LOST CREEK ISR, LLC

Re: Response to 7th Round LQD Comments

**RESPONSES TO JANUARY 2011 WDEQ/LQD COMMENTS
ON
THE MAIN PERMIT DOCUMENT**

**RESPONSES TO THE JANUARY 2011
WDEQ-LQD COMMENTS
on the
MINE UNIT 1 PACKAGE**

FIGURE MU1 4-2b
Monitor Well Re-Completion
Type 2 - Screen Outside of
Casing Only
Lost Creek Permit Area

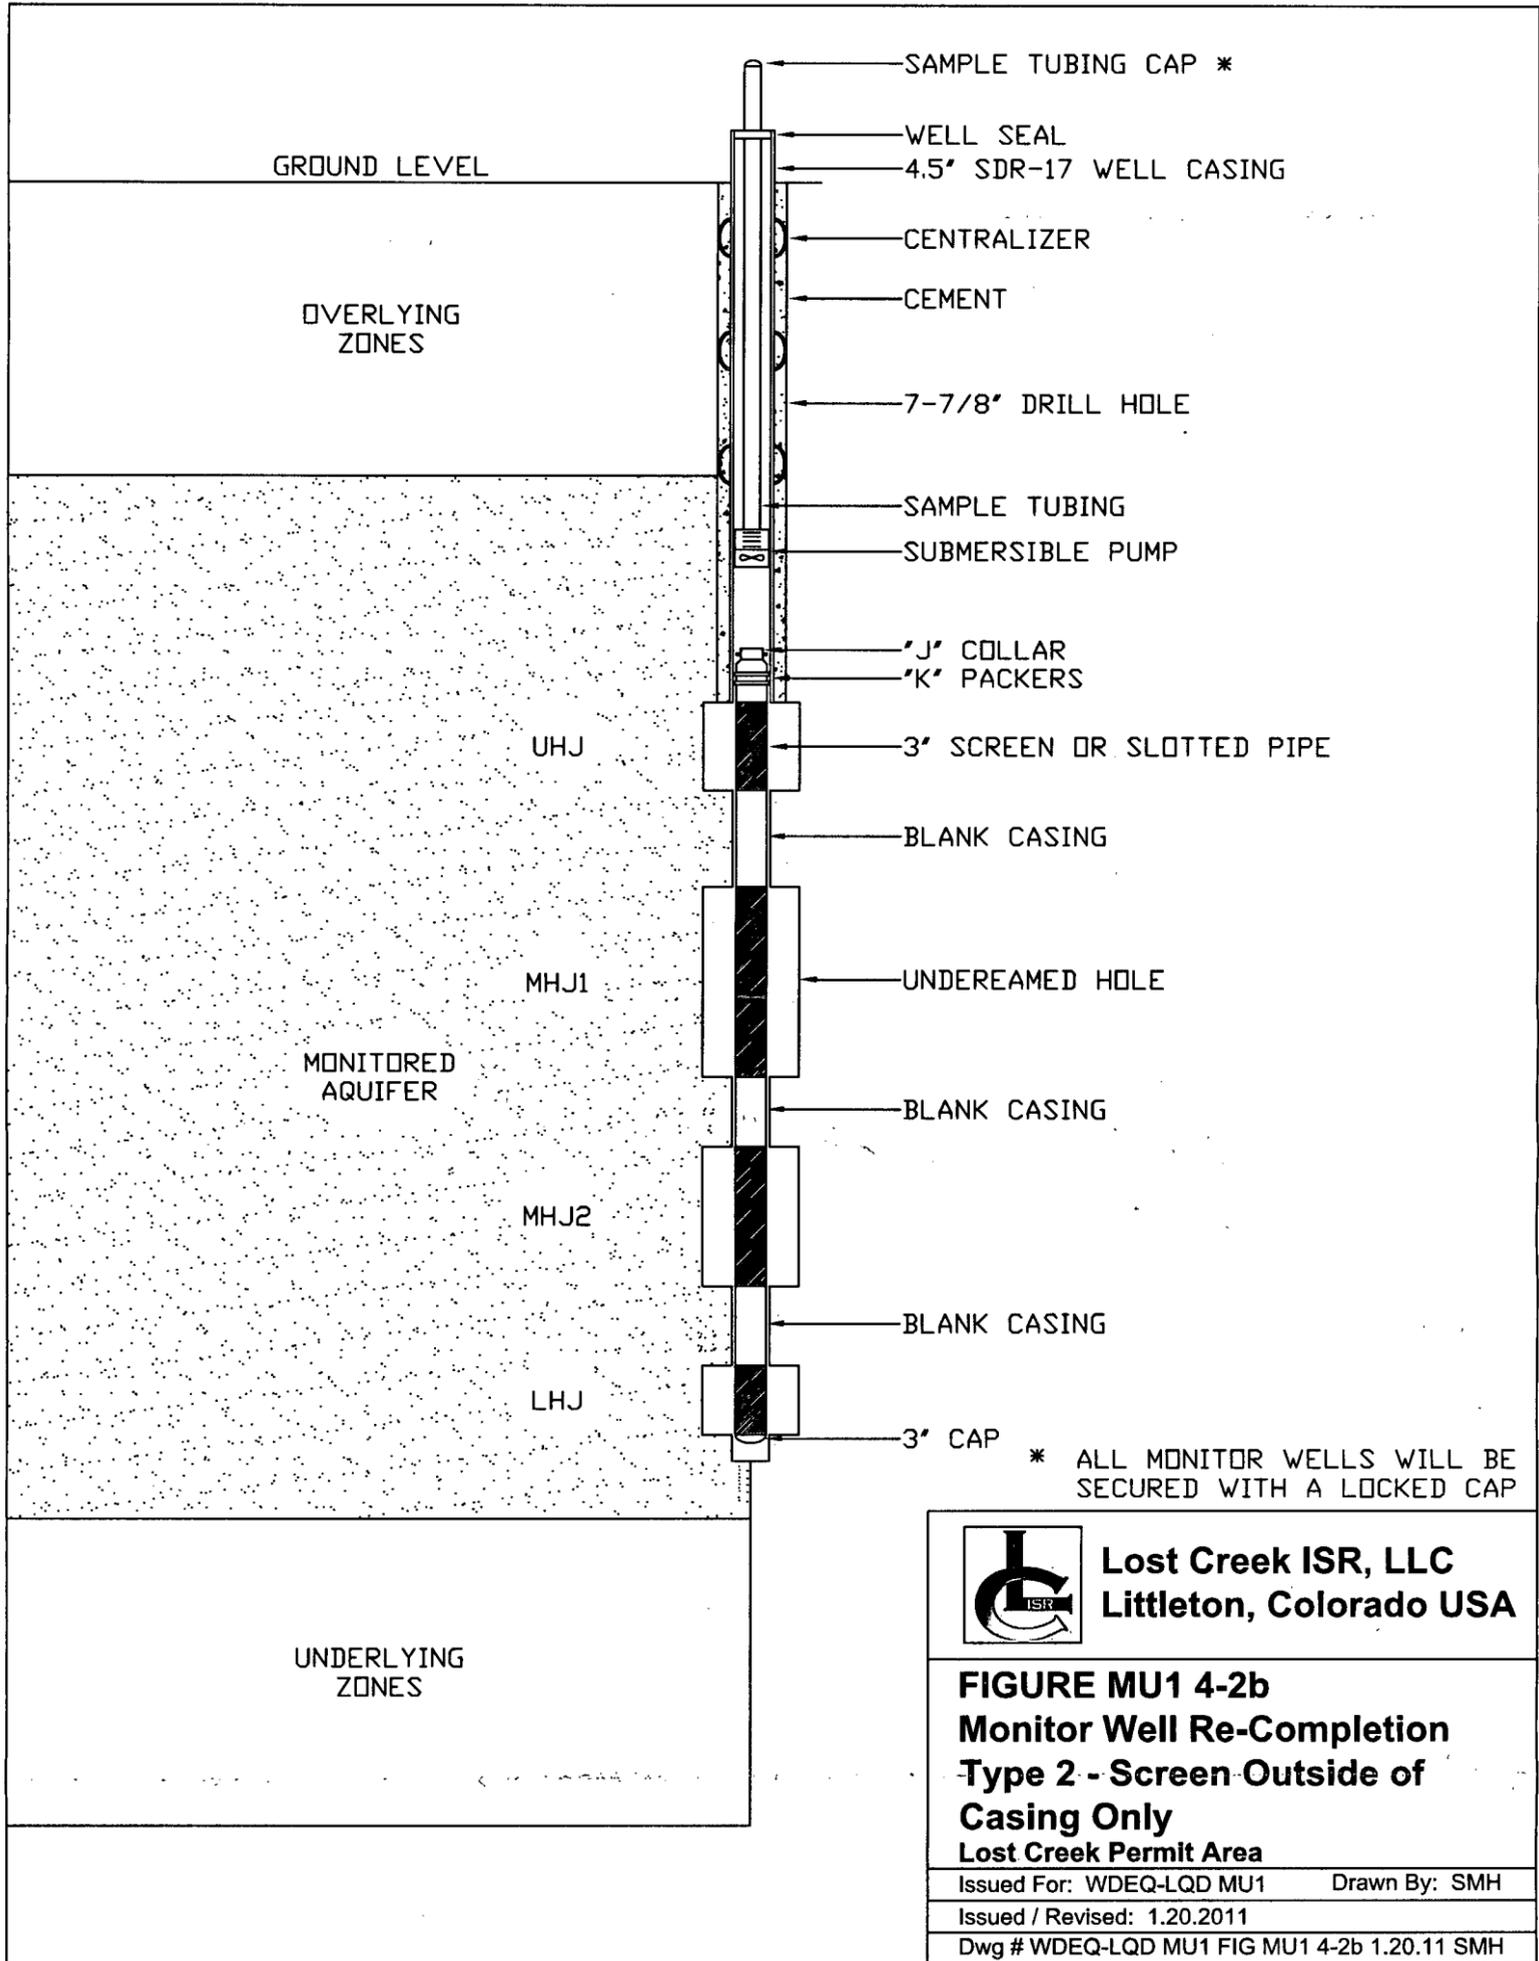
NC-12/10) LQD - *(This is a new comment resulting from the new information in LC ISR's 11/10 submittal). It is unclear how the sections noted as "open hole" on Figures MU1-4b and MU1-4c will isolate the intervals not intended to be monitored. That is, the text in the bottom of the second paragraph on Page MU1-14 (Section 4.1) states "Each of the three recompletion techniques involves placing a screen through the interval being monitored and a blank or casing across the intervals being isolated [emphasis added] from monitoring. However, the presence of "open hole" appears to contradict the text. Please clarify. (MLB)*

LQD (1/11) – During the January 20, 2011 meeting, Steve Hatten changed the figures on his laptop computer to replace the term "open hole" with "blank casing". Melissa Bautz reviewed that proposed change and said it would work well. **The LQD awaits the submittal of new versions of these figures.**

LC ISR, LLC (2/11) - Figures MU1 4-2b and c were revised as requested and are included with this submittal. Figure MU1 4-2a did not contain the verbiage "open hole" and was therefore not revised.
